Sent: 9/09/2019 12:50:08 PM
Subject: submission re DA2019/0884 - 51 Redman Road
Attachments: Submission re DA2019 0884 51 Redman Road.pdf;

To the Assessing Officer Northern Beaches Council

Re: DA 2019/0884 51 Redman Road Dee Why

Figure 2: Window locations of Units 4 (L1) and 8 (L2) in relation to bulk of main dwelling

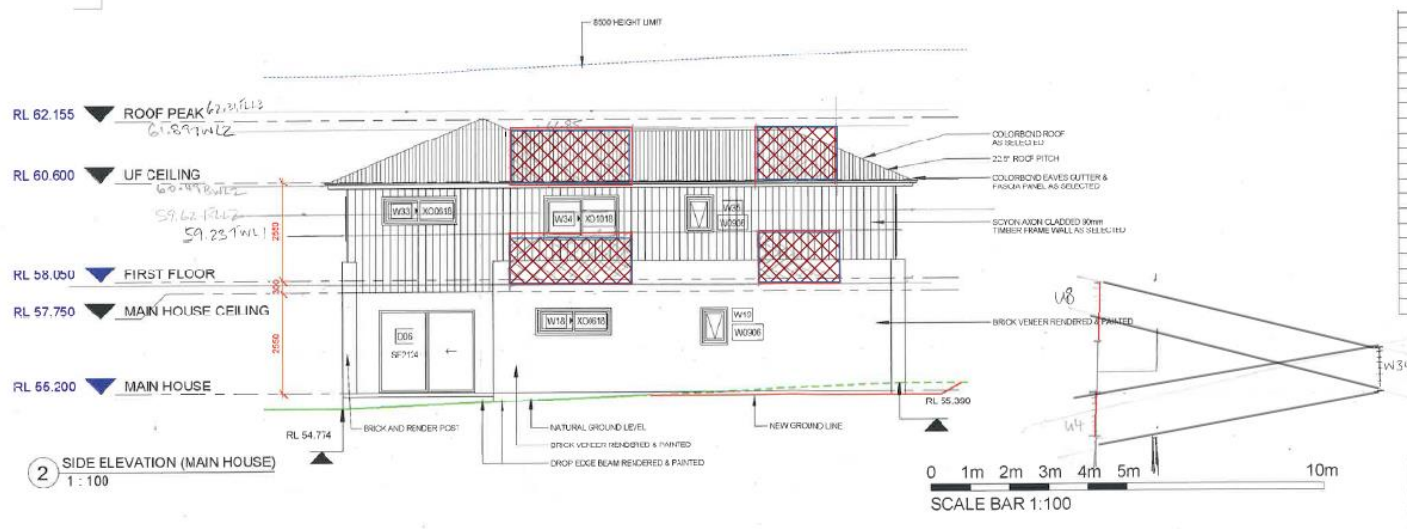
Given the height of the main dwelling, this is a particularly significant impact for Unit 4 (Level 1) and Unit 8 (Level 2). As demonstrated in Figure 2 below, by extrapolating the levels supplied in the site plan on Sheet A03 of the supplied plans and superimposing the window locations of these units (in red) onto Side Elevation 2 (which faces 53 Redman Road) on Sheet A11, the side of the main dwelling will not only dominate, but will in fact encompass the entire view available.

Referring again to Figure 2 above, drawn from Side Elevation 2 on Sheet A11 of the supplied plans and depicting the location of the windows of Units 4 and 8 in relation to the proposed main dwelling, Window W34, associated with Bedroom 3 of the proposed main dwelling, is centred within the same vertical alignment as the lounge windows (and corresponding balconies) of Units 4 and 8. This allows W34 to look down upon the private open space (balcony) and the lounge room window of Unit 4 from a distance of 5.4m and 7m respectively. Conversely, it also allows Unit 8 to look down into the bedroom associated with W34 from the same distances. The angle of view afforded at these distances represents a significant impact on privacy. This would appear to **fail requirement 4 of Section D8 of the WDCP**.

This visual impact can be completely eliminated by relocation of the 2 storey main dwelling to the front of the block, as is consistent with the local neighbourhood character, where the main bulk of the development will then be located in front of garages only.
